Dealer Service Instructions for:

Safety Recall No. B02

Floor Shifter Secondary Detent System

1993-1998 (ZJ) Jeep® Grand Cherokee

Figure 1

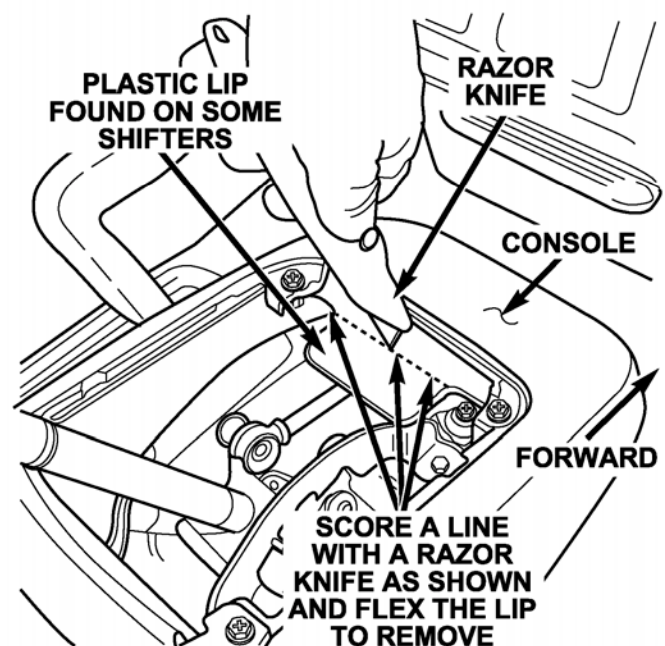
4. Using a plastic trim stick or equivalent, remove the shifter PRNDL bezel and disconnect the PRNDL light.
5. Some vehicles may have an additional plastic lip on the console bracket (Figure 1). If this lip is present, score the lip with a razor knife as shown in Figure 1 and then flex the lip to detach it from the console bracket. Discard the lip, it is not required for proper shifter function.

Figure 2

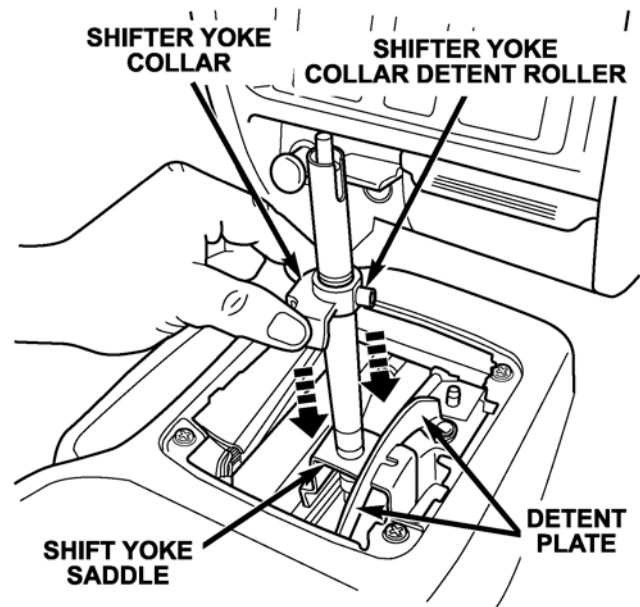
6. Remove the front and rear passenger side floor shifter mounting nuts.
7. Install the shifter yoke collar over the shifter yoke (Figure 2).

NOTE: The shifter yoke collar must be fully seated on the shifter yoke saddle. On some vehicles the roller on the shifter yoke collar may not pass by the detent plate and fully seat. To correct this condition, bend the detent plate with pliers near both rivets just enough to allow the shifter yoke roller to pass by the detent plate without contact.

Figure 3

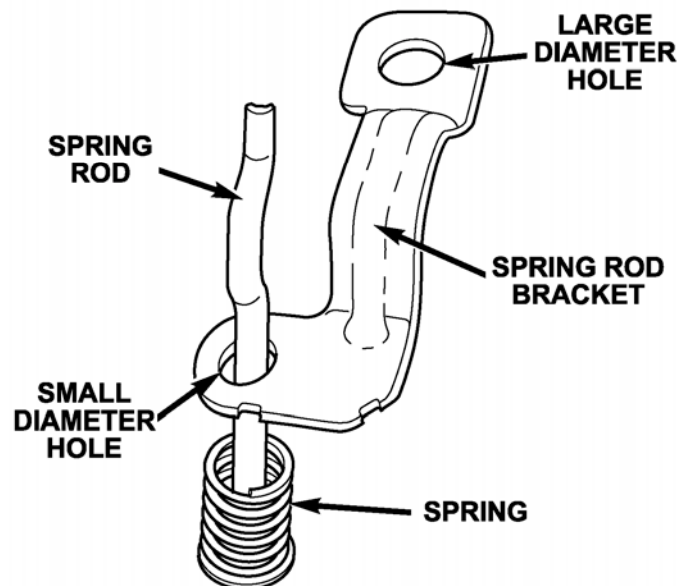
8. Insert the spring rod through the spring rod bracket as shown in Figure 3.

Figure 4

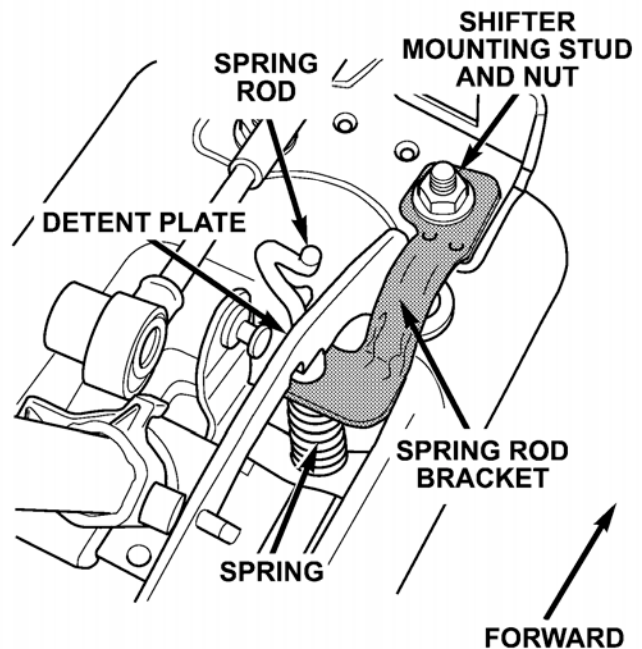
9. Install the spring rod and spring rod bracket assembly under the detent plate and onto the front mounting stud (Figure 4).
10. Install the front floor shifter mounting nut onto the stud. Tighten the nut to 220 in-lbs. (24 N·m).
11. Move the shifter lever to the reverse “R” position.
12. Hook the spring rod through the detent lever (Figure 5).

Figure 5

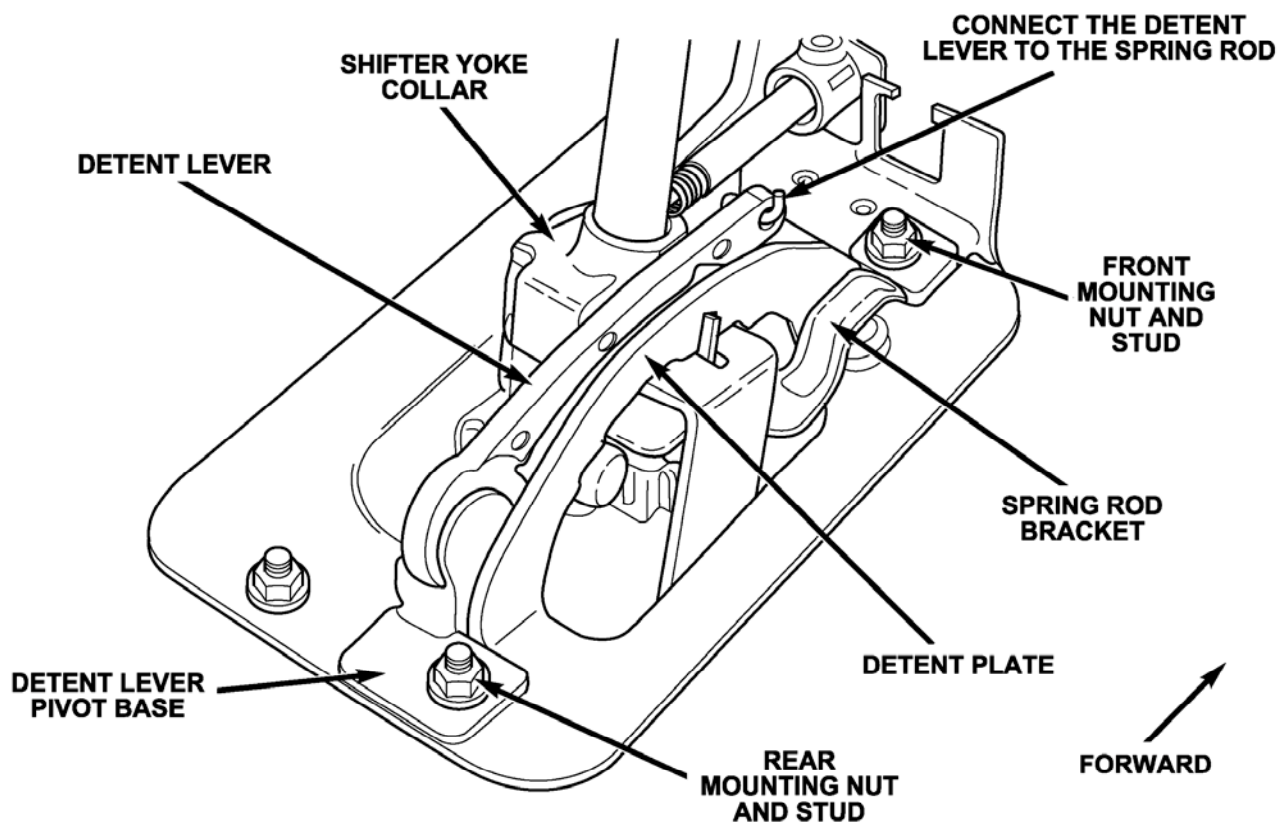
NOTE: The spring rod must be oriented through the detent lever as shown in Figure 5.

13. Install the detent lever pivot base over the rear shifter mounting stud (Figure 5).
14. Install the rear floor shifter mounting nut onto the stud and tighten to 220 in-lbs. (24 N·m).

CAUTION: The shifter must be in the reverse “R” position when tightening the floor shifter mounting nut.

Figure 6

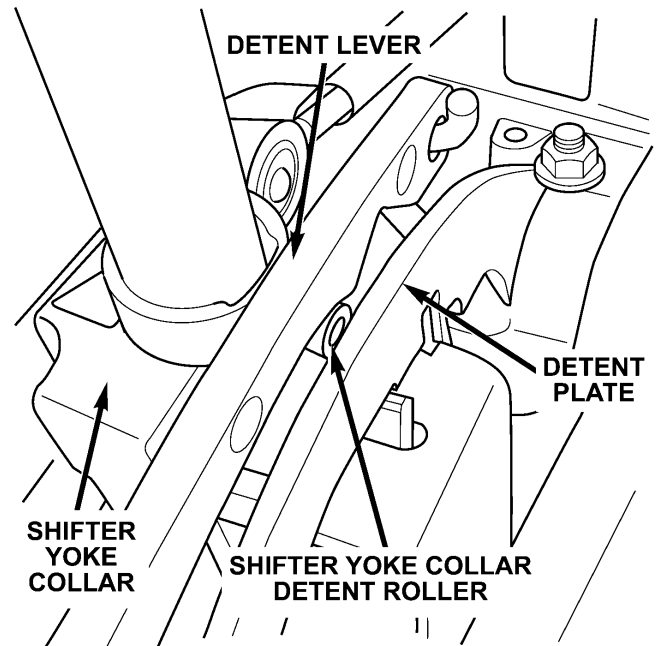
15. Verify that the detent lever is positioned (centered) directly over the shifter yoke collar detent roller (Figure 6).
16. Cycle the shifter lever from reverse “R” to “1” and then to the park “P” position.

Figure 7

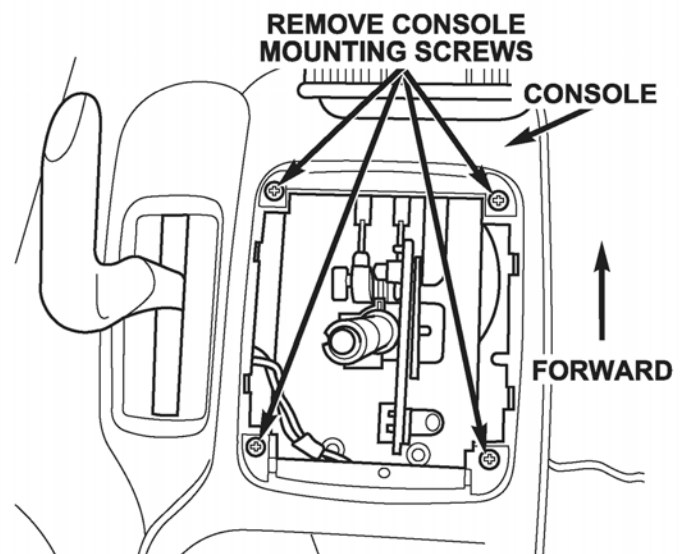
17. Place the ignition key in the “LOCK” position and verify that the key can be removed from the lock cylinder.
18. Remove the four (4) console-to-console bracket Phillips head mounting screws (Figure 7).
19. Lift the console slightly and place one (1) washer between the console mounting bracket and the console at each of the four (4) screw locations to shim the console upward (Figure 7).

20. Reinstall the four (4) console mounting screws (Figure 7).
21. Install the light into the PRNDL bezel.
22. Snap the PRNDL bezel into the console.
23. Install the shifter knob.
